VSP - 149
DATE: December 16, 2002 (M)

SUBJECT: Distribution of: **Kelly Aerospace Service Bulletin No. A-107A**

Bulletin No. A-107A

SUBJECT: Inspection of Fuel Regulator Shutoff Valve as Used With Kelly Aerospace Combustion Heaters, Models B1500-B4500

Figure 1

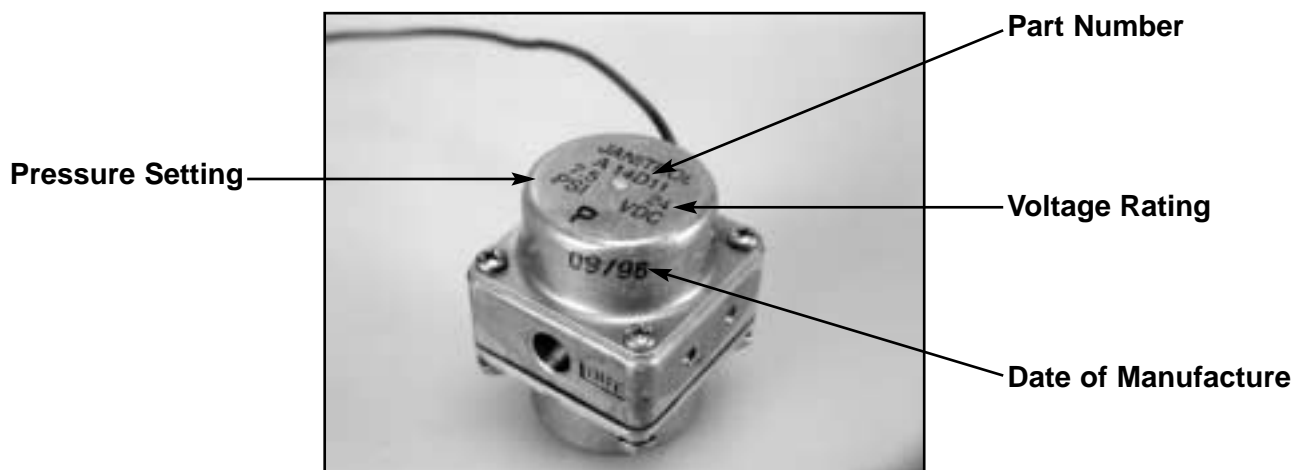
Kelly Aerospace part number 14D11 and 23D04 series fuel regulator and shutoff valves provide positive fuel shutoff and regulation of fuel inlet pressure to Kelly Aerospace model B1500-B4500 series combustion heaters as used on both piston powered and turbine powered business aircraft. These valves operate at inlet pressures of 4-50 psi depending upon installation and regulate fuel outlet pressure (inlet supply to the heater) to 1.0 psi, 7.5 psi, or 12 psi depending upon application. Each valve is identified with part number, pressure setting, voltage rating, and date of manufacture as shown in Figure 1.

- 6) If no signs of fuel stains are found, mark the valve cover with date of inspection (month/year) using permanent ink and letters .12 - .25" high next to or below the date of manufacture. For example, a valve inspected in June 2002 should be marked 06/02. **CAUTION, re-install the valve in accordance with the applicable aircraft maintenance manual exercising care to follow safety precautions.** Record Service Bulletin compliance in the logbook.

Figure 2

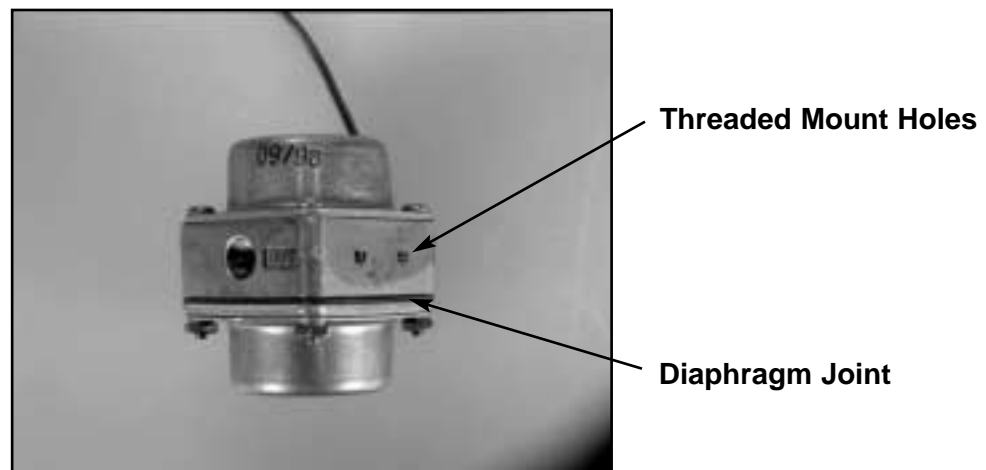
Recent field reports have indicated the possibility of fuel seepage at either the diaphragm joint or threaded mount holes as shown in Figure 2. Within the next 10 hours of operation, inspect the pressure regulator shut off valve for signs of fuel leakage as follows.

- b. Using mineral spirits or JET-A as the test fluid, pressurize the inlet port of the regulator valve to 50 psi for 1 minute minimum with the solenoid energized. Carefully inspect the valve body for signs of fuel leakage giving careful attention to the diaphragm joint and the threaded mount holes as shown in Figure 2. **CAUTION - prior to test, exercise care to wipe valve body and fittings free of any residual fluid that may have contacted external surfaces of the valve during test setup.** Leakage may appear as a wetness or seepage at the diaphragm joint or threaded mount holes. Rotate the valve during pressure test as necessary to fully inspect all external surfaces.

- 5) Visually inspect the valve body for signs of fuel stains, paying careful attention to the diaphragm joint and the threaded mounting holes located in sides of the valve body (see Figure 2). Fuel leakage in those applications using AVGAS may appear as a greenish blue stain or residue in the area of the diaphragm joint or threaded mount hole. Fuel leakage in those applications using JET-A fuel may appear as a wetness or oily residue at the diaphragm joint or threaded mount hole. Utilize supplemental lighting if needed to facilitate visual inspection. Visual inspection must include all four sides of the regulator valve body. If signs of fuel leakage are found replace the valve using a new valve of appropriate part number with a manufacture date code of 02/02 or later. Record valve replacement and Service Bulletin compliance in the logbook.

- c. If signs of fuel leakage are found replace the valve using a new valve of appropriate part number with a manufacture date code of 02/02 or later. Record valve replacement and Service Bulletin compliance in the logbook.
